Duke Power

SUBJECT: Oconee Nuclear Station - Unit 2
Docket No. 50-270
Response to Request for Additional Information
Request to use an Alternative to ASME Boiler and
Pressure Vessel Code, Section XI in accordance with 10
CFR 50.55a(a)(3)(ii), (RR-01-06, RAI)

RESPONSES TO RAI
REGARDING THE USE OF AN ALTERNATIVE TO
ASME CODE REQUIREMENTS CRDM NOZZLE WELD REPAIR
OCONEE NUCLEAR STATION, UNIT 2
DUKE ENERGY COMPANY

Figure 2-13
Diffusible Hydrogen Levels at Various Shielding Gas Dewpoint Temperatures

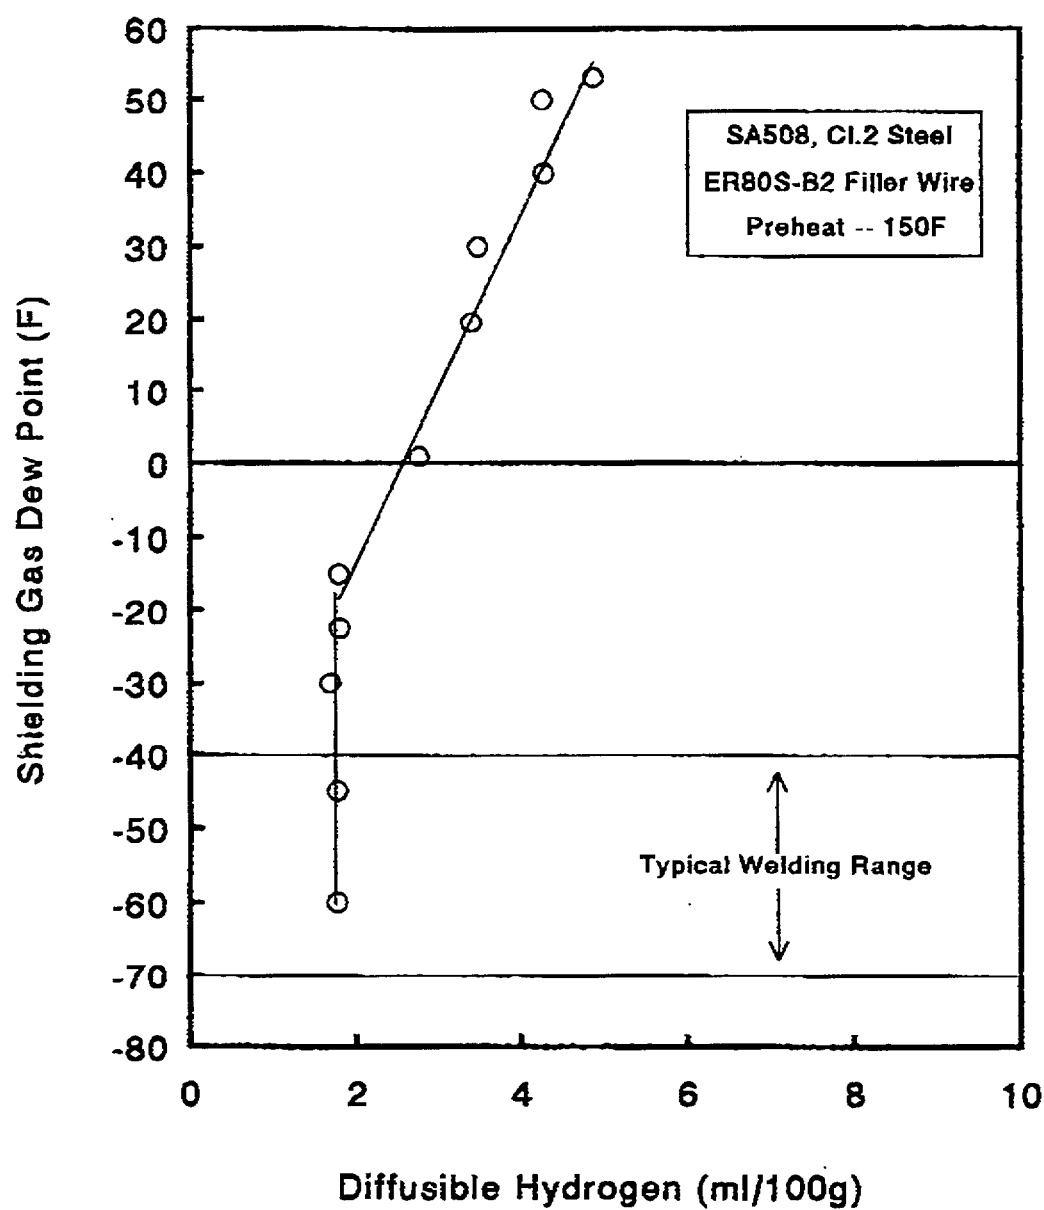
On page 11 of the submittal, it states that EPRI tests show gas mixtures (argon and moisture) as high as +60 degrees F dew point will produce a hydrogen concentration per deposited weld metal of 4.6 ml/100g. Provide a copy of EPRI report.

The subject EPRI Report, TR-103354, "Temperbead Welding Repair of Low Alloy Pressure Vessel Steels: Guidelines,"

dated December 1993, contains over 200 pages. The pertinent section of the report is provided as Attachment C.

The results of the diffusible hydrogen measurements carried out employing shielding gas dewpoints from -60F to +60F are presented in Figure 2-13. The maximum measured diffusible hydrogen level (measured at +60F) was 4.6ml/100g H₂. The level decreased with decreasing dewpoint temperature until a minimum diffusible hydrogen level of 1.86ml/100g H₂ was reached at a dewpoint of -15F. Between -15F and -60F the diffusible hydrogen content remained essentially constant at 1.86ml/100g H₂.
